Review of Fonterra's 2017/18 base milk price calculation: Dairy Industry Restructuring Act 2001

Final report

Date of publication: 14 September 2018

Figure 2.1 Percentage seasonal decline in total kgMS collected by Fonterra

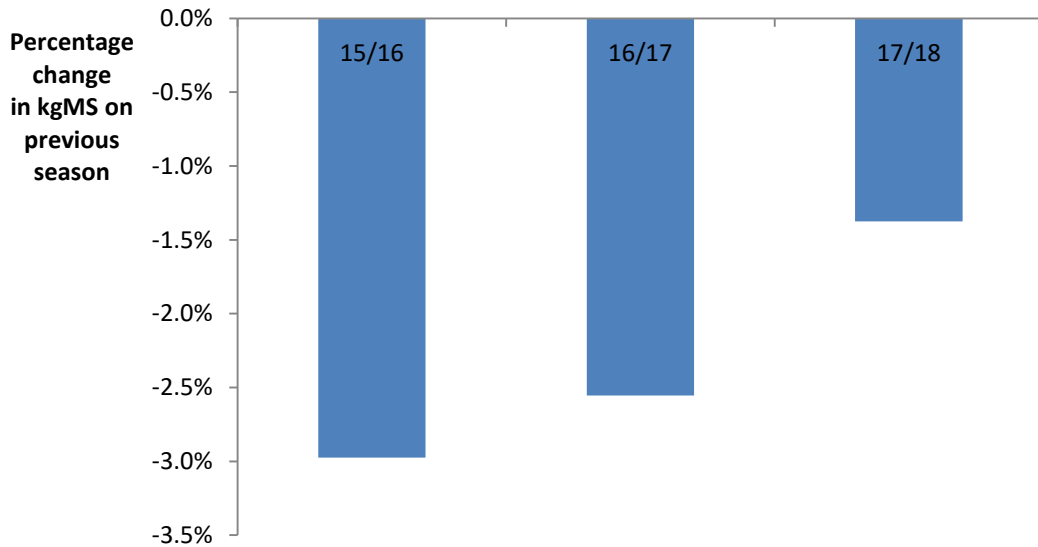
2.31 Although there can be slight seasonal variations in milk volumes, the milk volume in the 2017/18 season decreased overall by 1% relative to the 2016/17 season, to a total of 1,505 million kgMS. The lower than expected volume was driven primarily by adverse weather conditions in the early part of the 2017/18 season. This is the third season in a row that has seen a decline in total milk volumes collected by Fonterra.

2.32 This season there was a larger reduction in milk volumes in the first part of the season, with an increase in the milk volume collected in the second half of the season. The 1% reduction for the season overall is the net position.

2.33 In response to the reduced volume in the earlier part of this season, Fonterra made an adjustment to the calculation to reflect a notional temporary “mothballing” of older plants of the notional producer in order to match up milk volumes with production capacity. We believe the lower volumes in August and September would have given the NP sufficient information to modify its forecasts and temporarily mothball plants. We consider this to be an appropriate real world response when faced with reductions in milk volume.¹⁶
